**APPLICATION FOR PERMISSION
UNDER SECTION 16 OF
THE TOWN PLANNING ORDINANCE
(CAP. 131)**

Revised drainage design is prepared to address the previous comments issued by Drainage Services Department (DSD) issued via the letter from Planning Department dated 8 October 2024 (Planning Department's Ref: DPO080824OB-B8354) (see **Annex 1**).

**Proposed Temporary Vehicle Park (Medium and Heavy Goods Vehicle) and Open Storage
(Operation Tools and Materials) for a Period of 3 Years and Filling of Land
in “Residential (Group D)”, Lot 82 S.B ss.1 (Part) in D.D.108,
Fan Kam Road, Pat Heung, Yuen Long
(Planning Application No. A/YL-PH/933)**

**Compliance with Approval Condition (e)
Submission of a Revised Drainage Proposal**

DRAWING TITLE :
SITE DRAINAGE LAYOUT

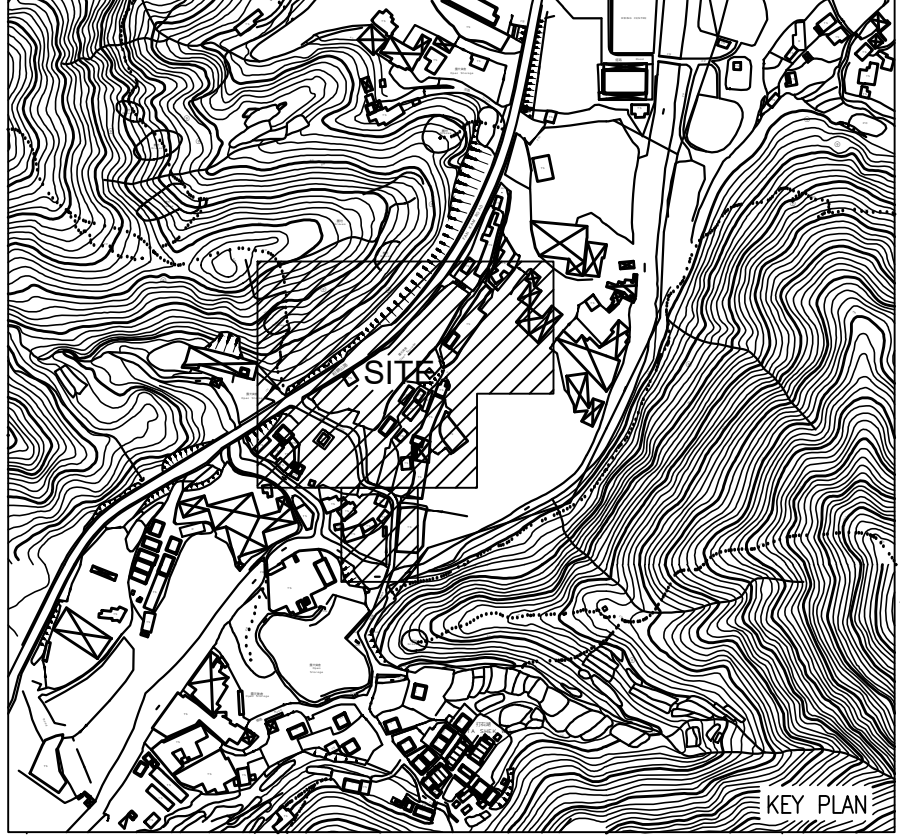
(d)	The proposal should indicate how the runoff (the flow direction) within the site would be discharged to the proposed u-channel.	The flow directions within the site are shown on drawing no. A01 in Annex 2 .

DETAIL OF SAND TRAP & TERMINAL MANHOLE

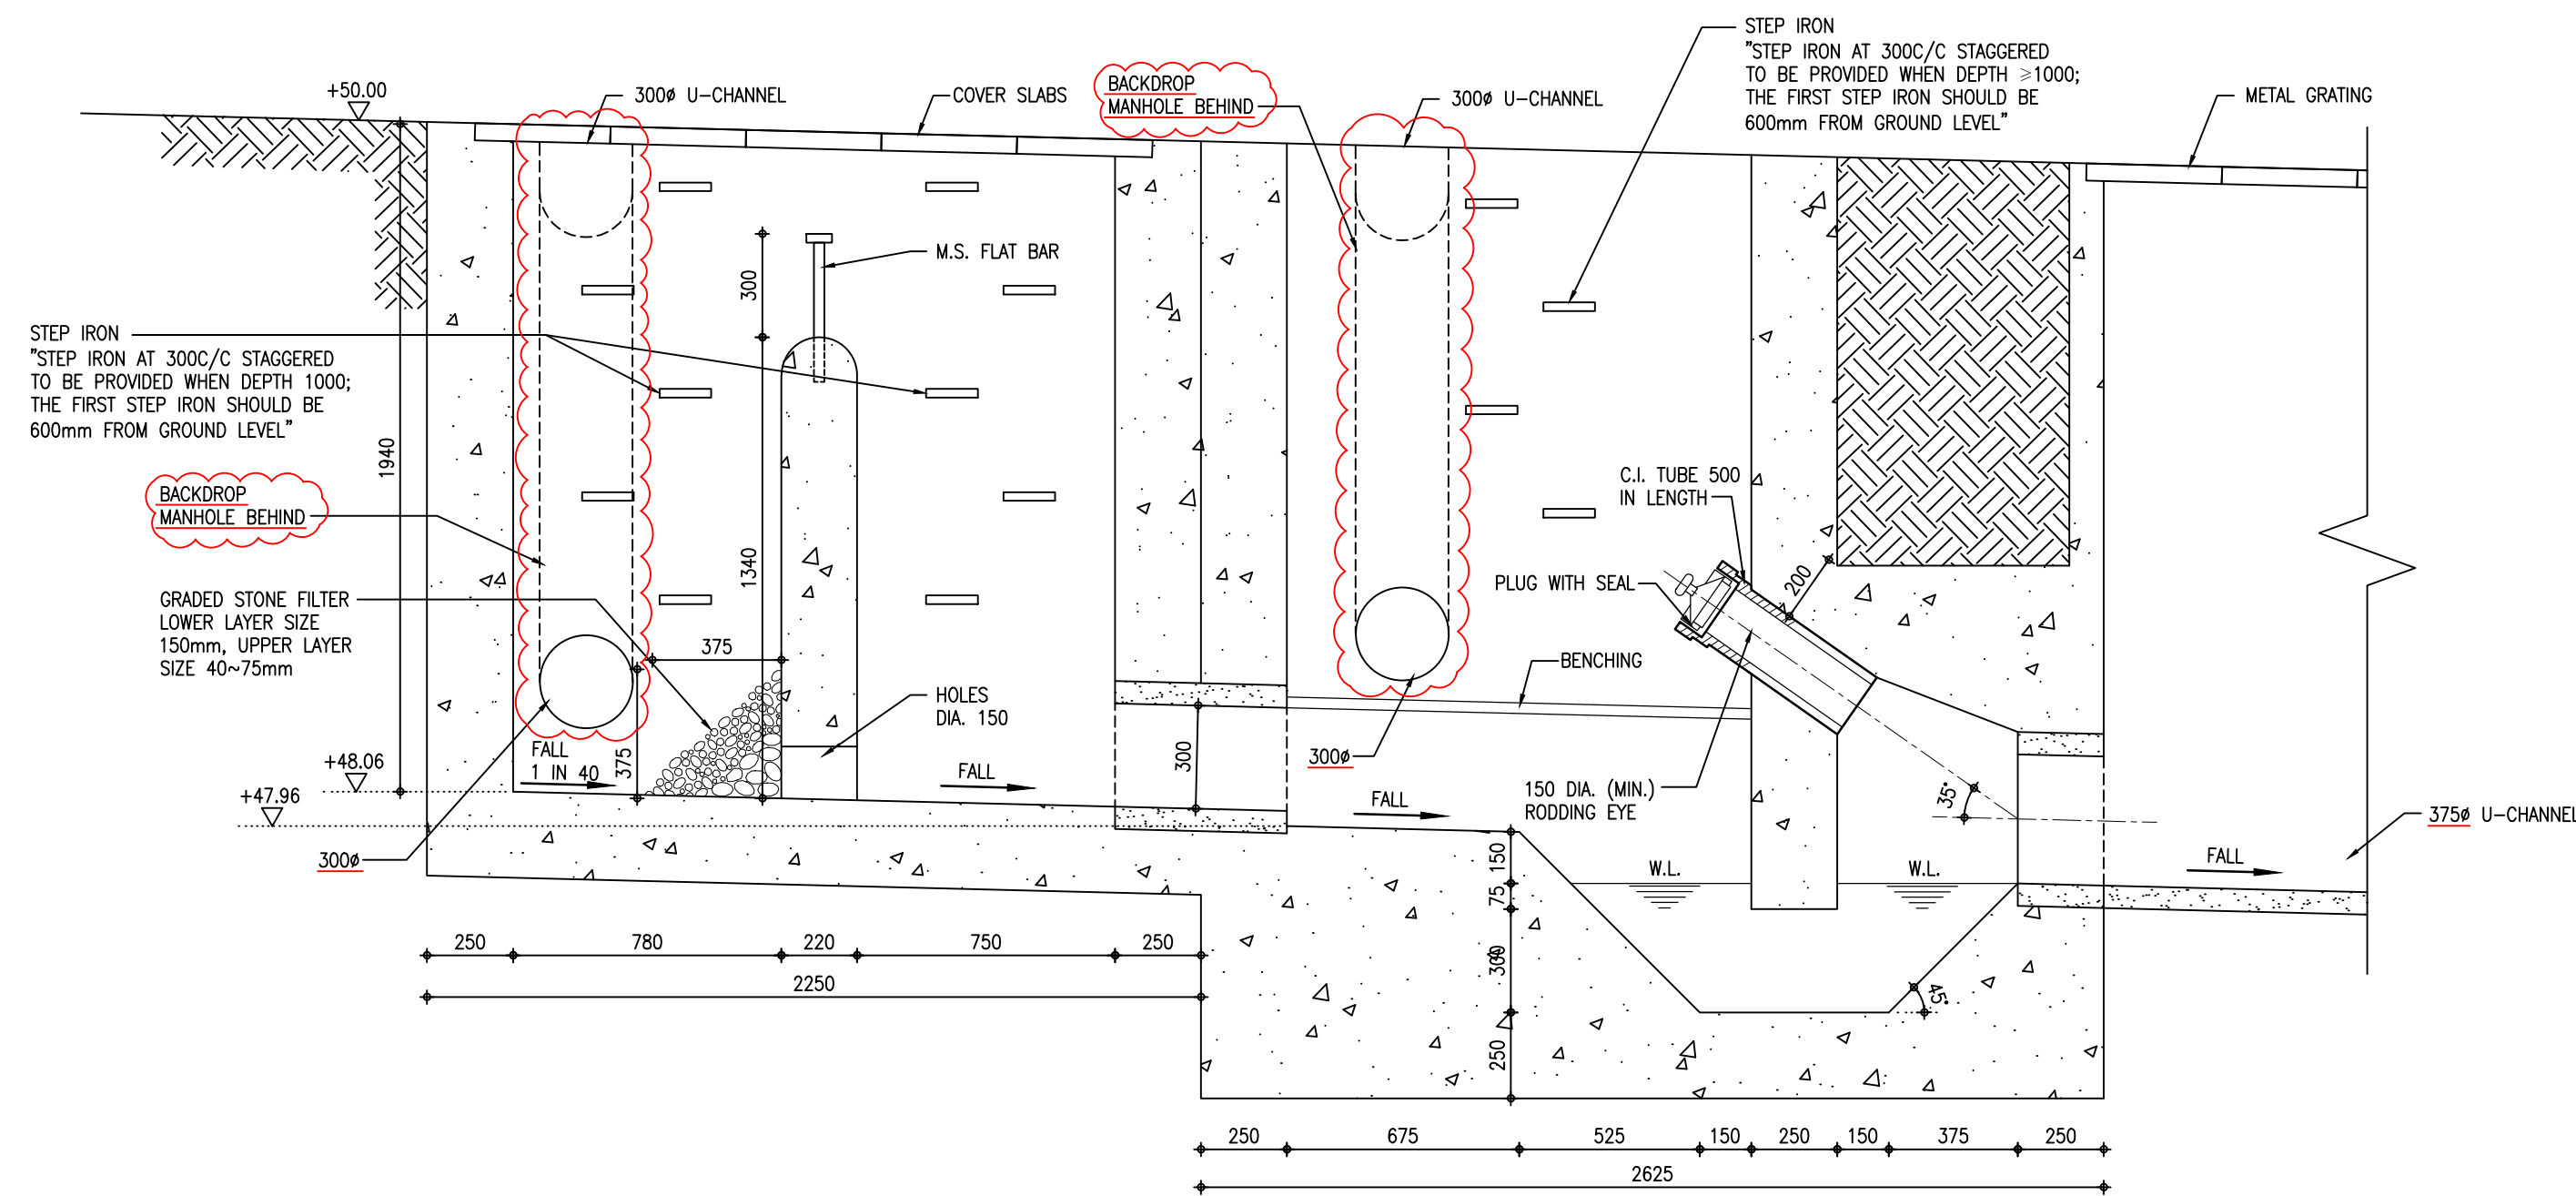
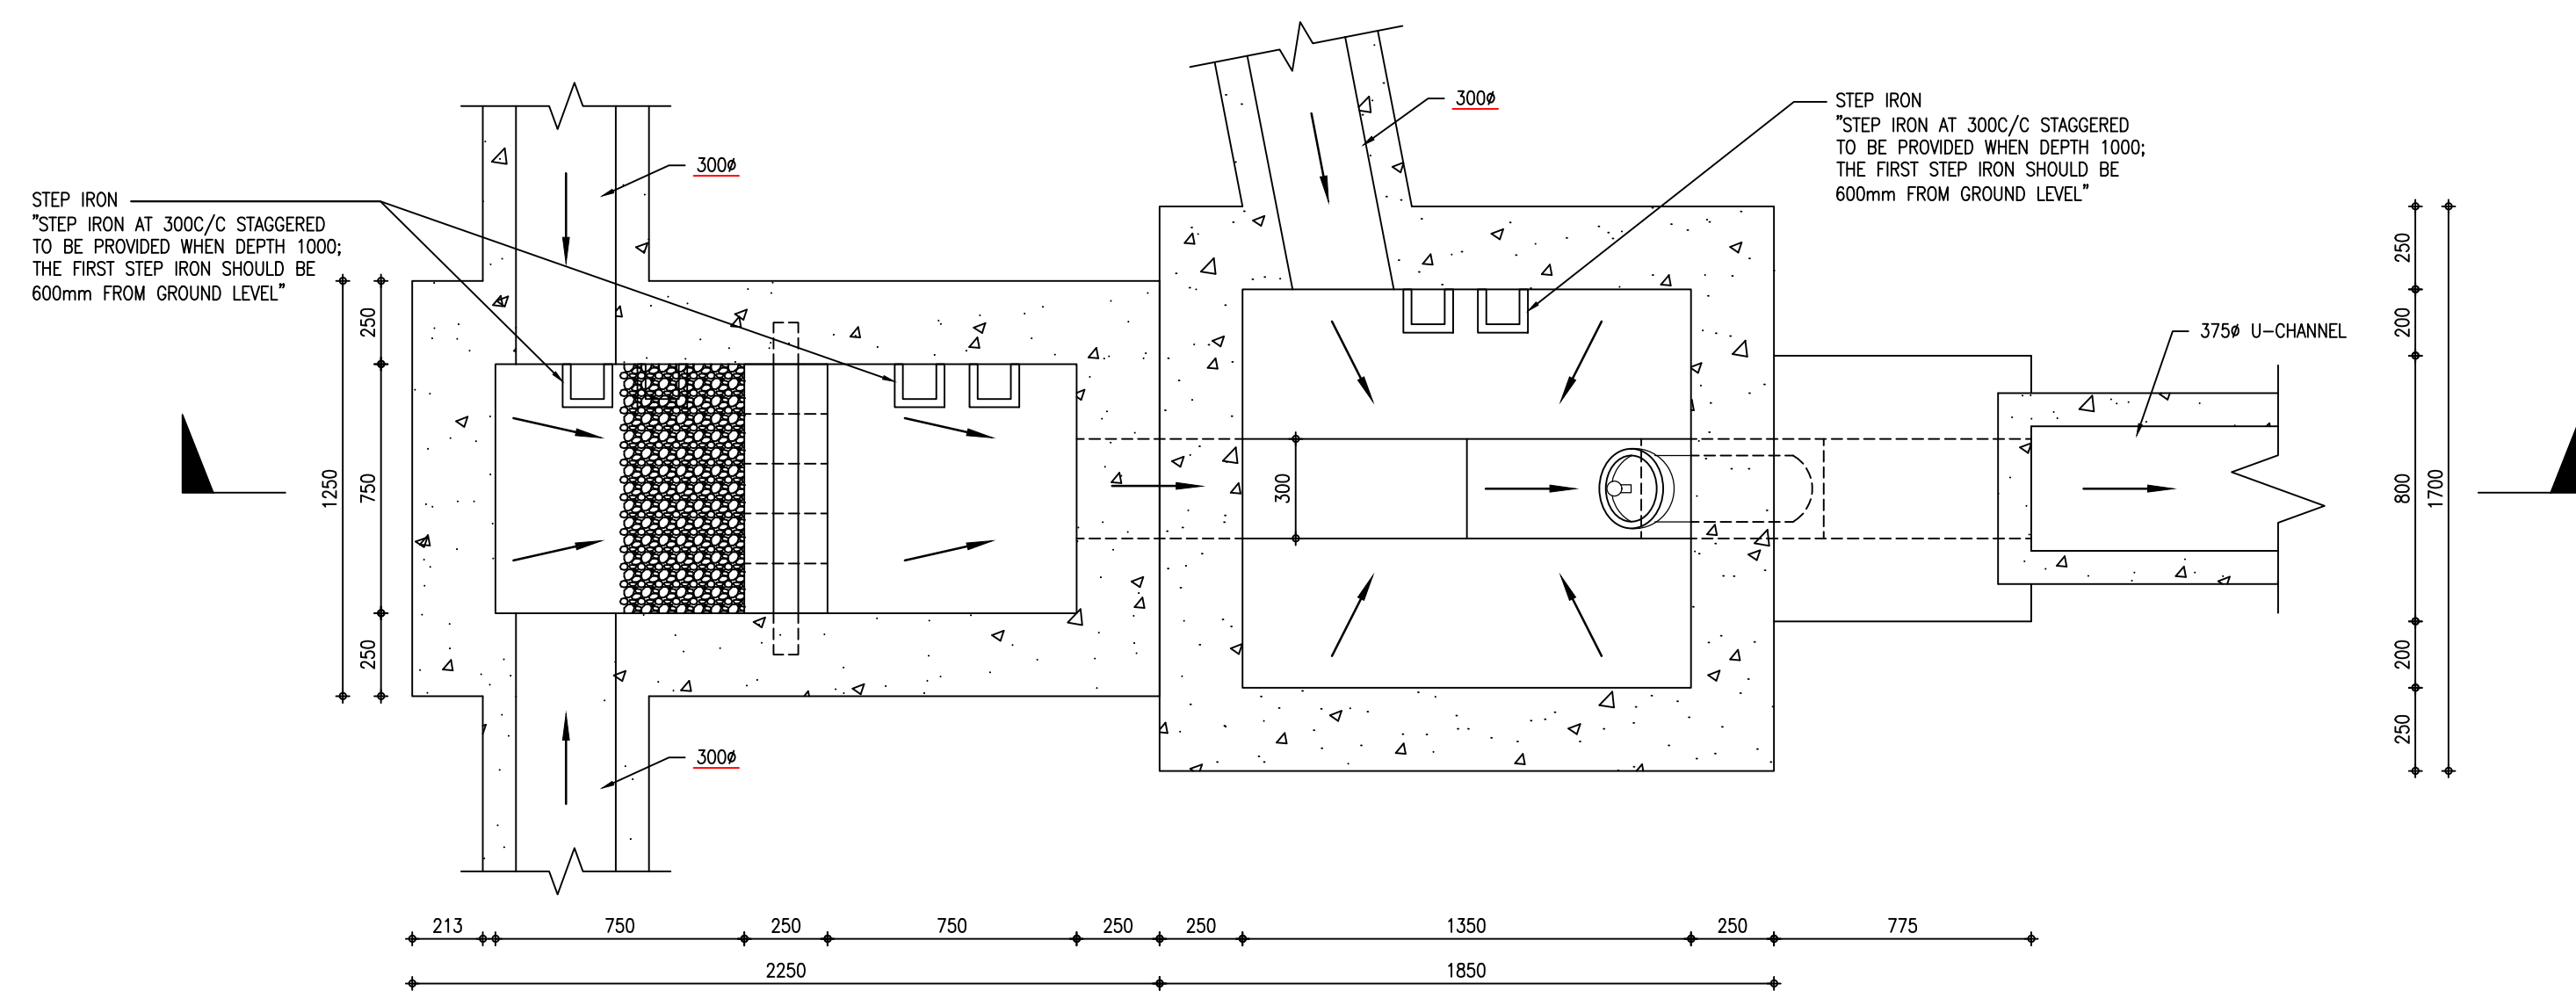
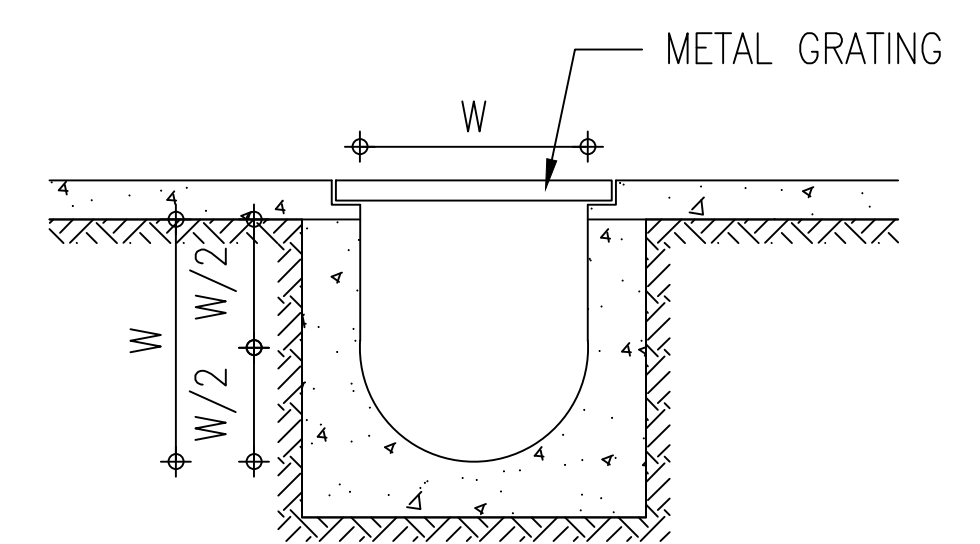
(m)	Standard details should be provided to indicate the sectional details of the proposed u-channel and the catchpit.	Standard details indicating the sectional details of the proposed u-channel can be found in drawing no. A02 (Annex 2) and in CEDD standard drawings no. C 2409J, C 2410I and C 2412E (Annex 3). Standard details indicating the sectional details of the proposed catchpits can be found in CEDD standard drawings no. C 2405/1 to C 2405/5 (see Annex 3).

SECTION B-B

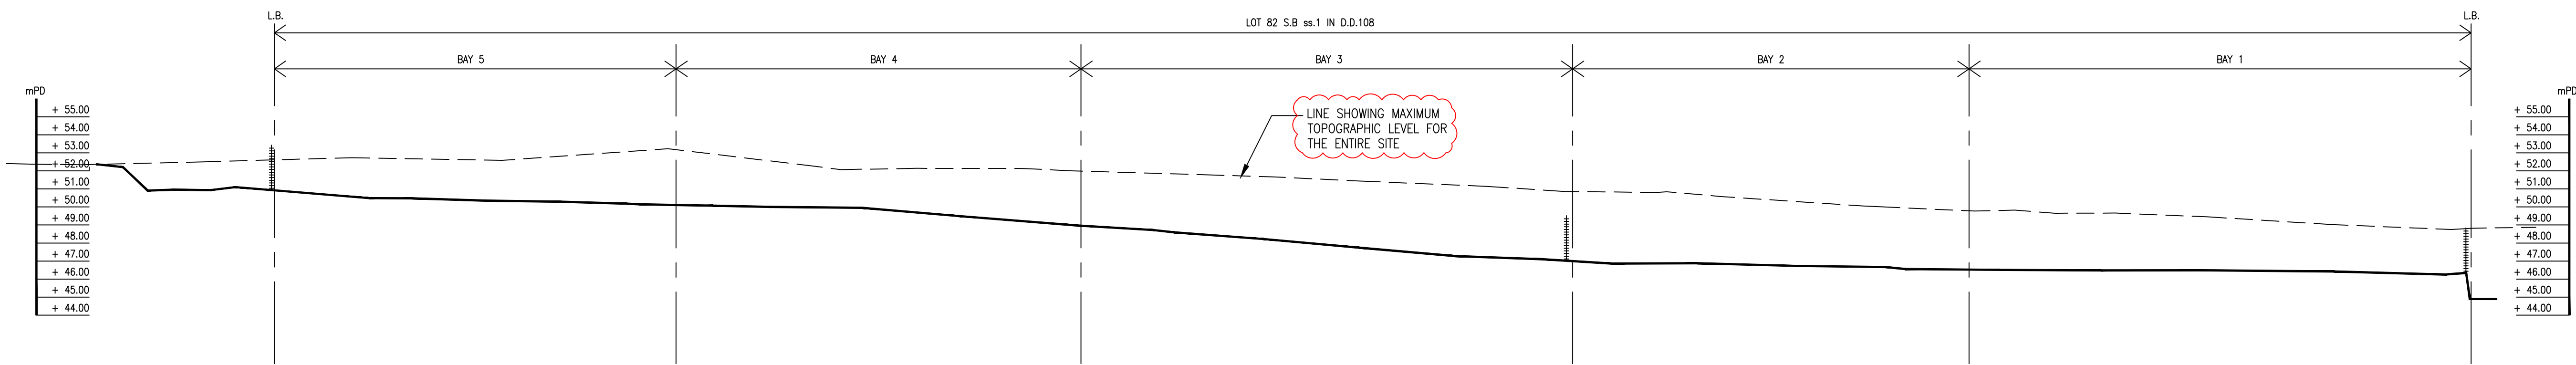
water pump discharge. Please refer drawing no.E-02 - Section B-B. details as follows:- - 1st duty water pump to the specified water level will be operated. - 2nd duty water pump to be operated when the water level high than or exceeding the specified water level of the 1st pump.
